PRODUCT BULLETIN

PRODUCT: 3370 Series Mechanical Lock
APPLICATION: Milled Post and Retainer Clip
BULLETIN: #LG01
DATE: 11/01/07

Modification to 3370 Series Mechanical Lock Case

Figure 1

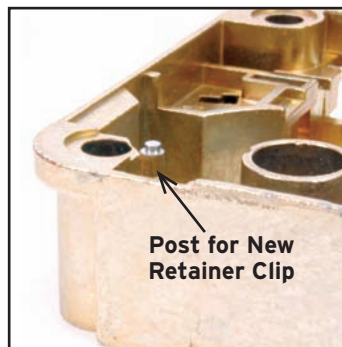
Figure 1 - The post that holds the anti-pick lever has been milled to facilitate the use of an "e" retainer clip (Figure 2). This will ensure that the spring and anti-pick lever will not shift when the back cover is removed.
